ECE/TRANS/WP.29/GRSG/2009/14
10 August 2009

**REGULATION No. 118
(Burning behaviour of materials)**

Proposal for draft amendments to Regulation No. 118

Submitted by the experts from France, Germany, Norway and Sweden */

Example 2

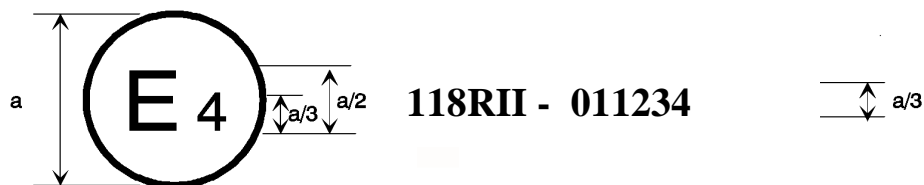
The above approval mark affixed to a component shows that the type concerned was approved in the Netherlands (E4) pursuant to Part II of Regulation No. 118 under approval number **011234**. The first two digits (**01**) of the approval number indicate that the approval was granted in accordance with the requirements of the **01 series of amendments to Regulation No. 118**.

Figure 4
Apparatus for testing the capability to repel fuel or lubricant
(Dimensions in millimeters)"

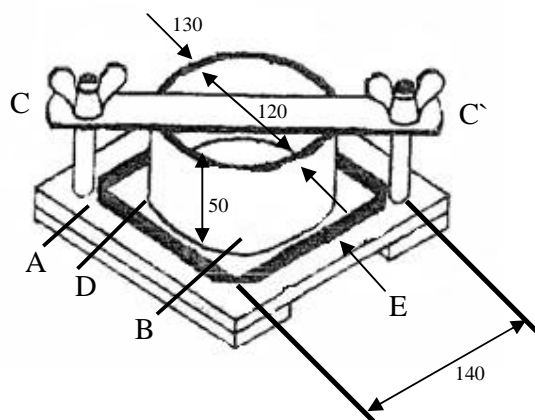
3. Apparatus (see figure 4)

B a metal cylinder (inner diameter of 120 mm, outer diameter of 130 mm, height of 50 mm), filled with the test medium;

- 4.3. The test sample, with its exposed face uppermost, shall be placed on the base of the apparatus by fixing the metal cylinder in a centred position with sufficient pressure on the screws. No test liquid shall leak.
- 4.4. Fill the metal cylinder with test liquid (fuel and/or lubricant) to a height of 20 mm and let the system rest for 24 hours.
- 4.5. Remove the test liquid, wipe the surface of the test specimen without pressing.
- 4.6. The test sample shall be weighed.
